NRC 2003-0050

DOCKETS 50-266 AND 50-301  
POINT BEACH NUCLEAR PLANT, UNITS 1 AND 2  
SUPPLEMENT 2 TO LICENSE AMENDMENT REQUEST 229  
TECHNICAL SPECIFICATION LCO 3.5.2, ECCS – OPERATING,  
AND LCO 3.5.3, ECCS – SHUTDOWN

**RESPONSE TO REQUEST FOR ADDITIONAL INFORMATION  
LICENSE AMENDMENT REQUEST 229, SUPPLEMENT 2  
TECHNICAL SPECIFICATION LCO 3.5.2, ECCS – OPERATING, AND  
LCO 3.5.3, ECCS – SHUTDOWN  
POINT BEACH NUCLEAR PLANT, UNITS 1 AND 2**

(b). PBNP Piping and Isometric Drawings, Auxiliary Coolant System (9 pages)

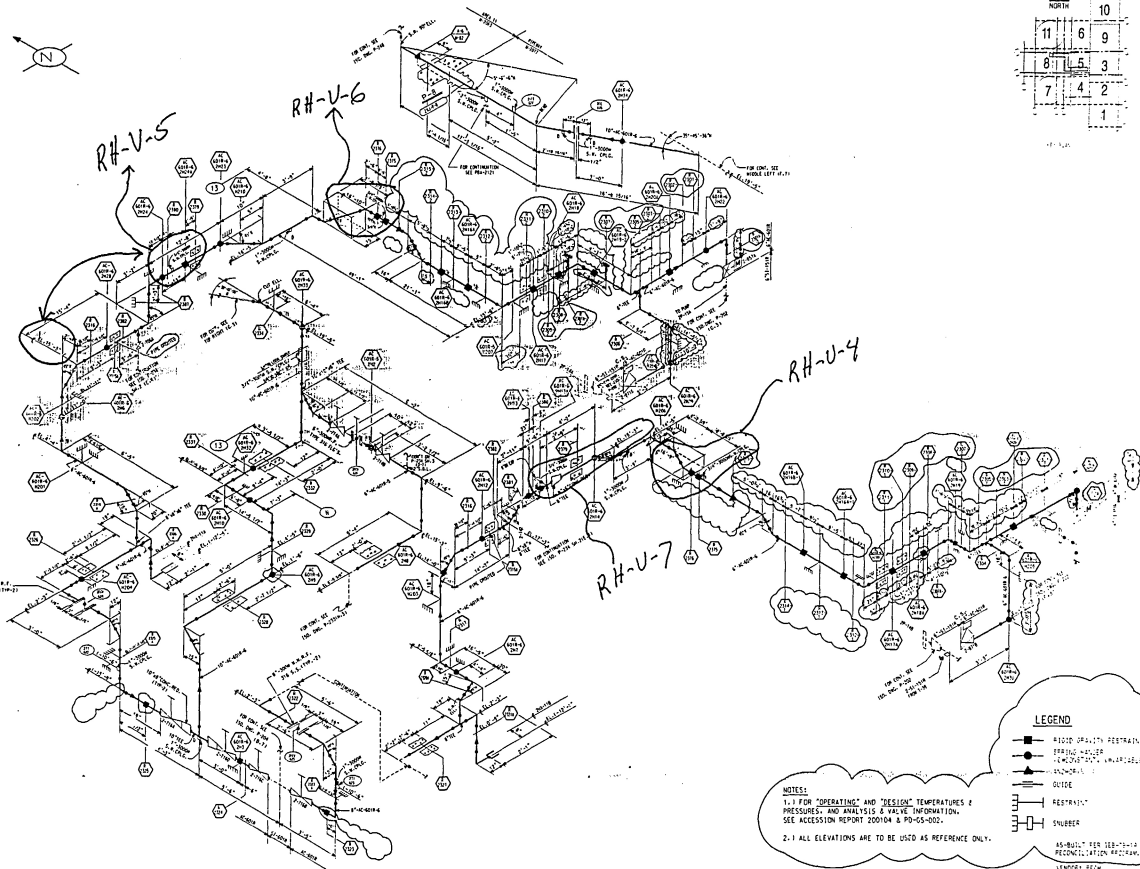
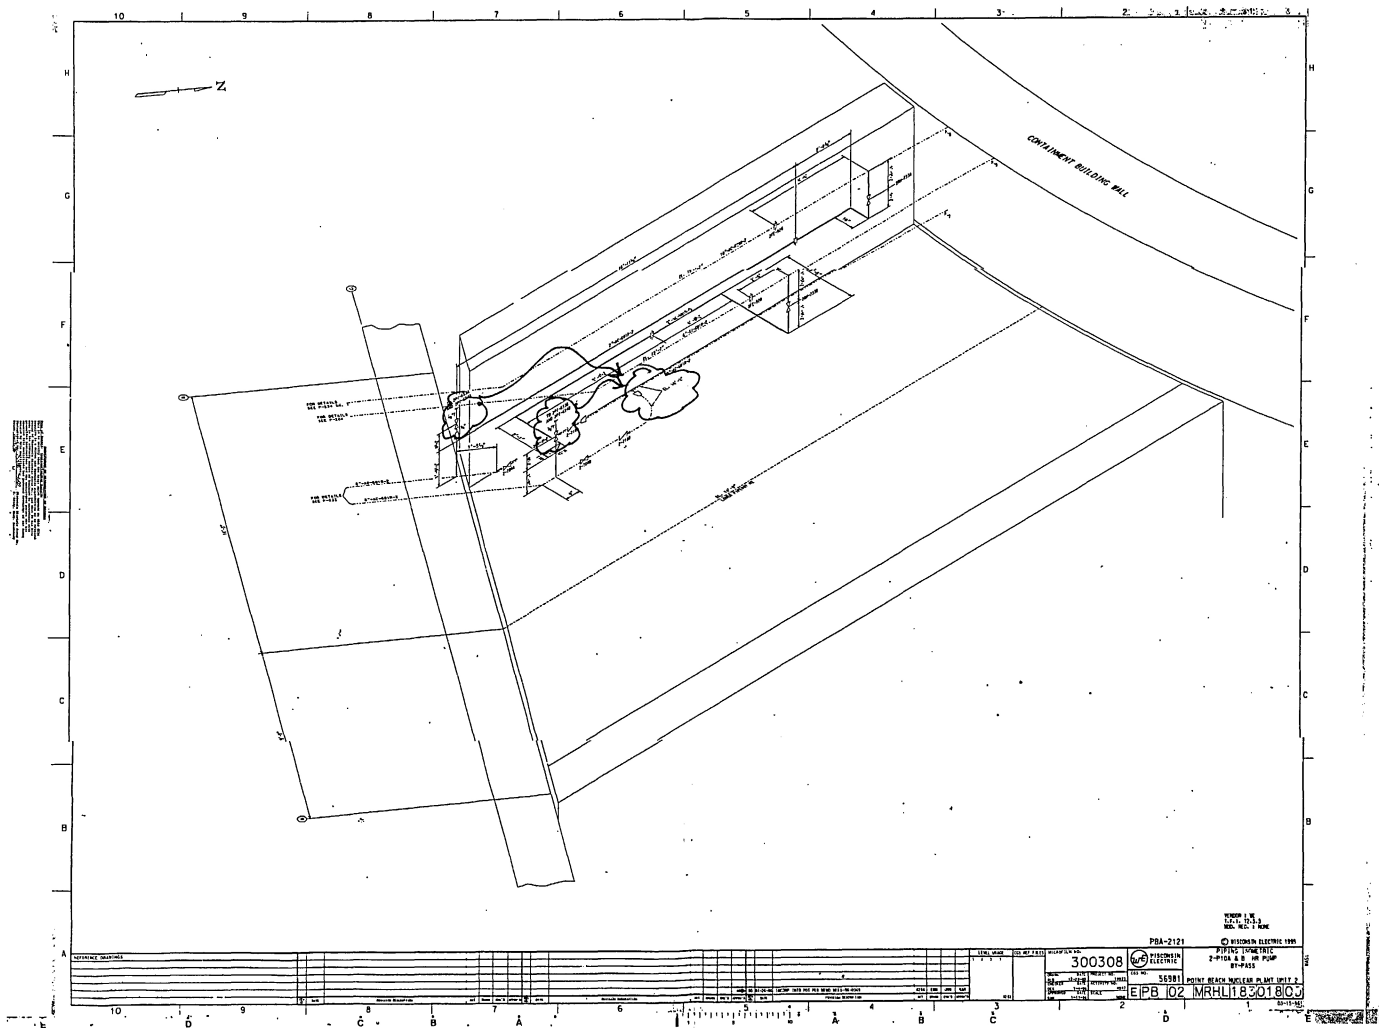
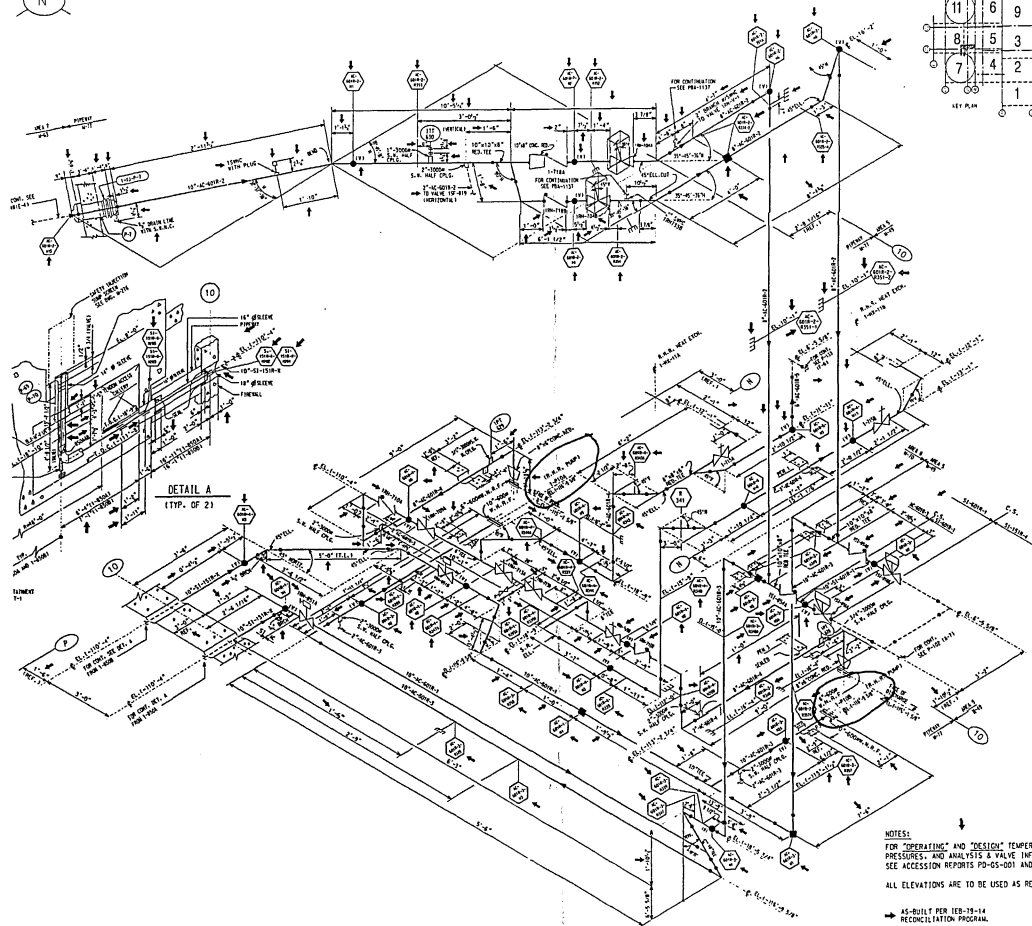
In page 4 of Attachment 1, you stated that RHR (residual heat removal) pump casings do not need to be vented because they are at system low points and because of their configuration. What is the location of the high point vents with the capability of venting the RHR pumps? Do you have any diagrams and/or information that will help us to understand the venting system?

Enclosures (b) and (c) to the letter transmitting this response provide Piping and Isometric Drawings of the Point Beach Nuclear Plant (PBNP) Auxiliary Coolant System and a RHR pump assembly drawing. The RHR pump casings are at the system low point and their configuration is such that gases are unlikely to collect there. The enclosed drawings show how the discharge volute of the RHR pump provides a direct path from the pump casing to the discharge piping. Gases that may come out of solution within the pump casing will likely rise up out of the casing and flow into the discharge piping due to the system configuration. The high point vents on the discharge piping are located to facilitate removal of this gas. Venting the accessible ECCS piping outside containment will minimize any voids and pockets of entrained gases.
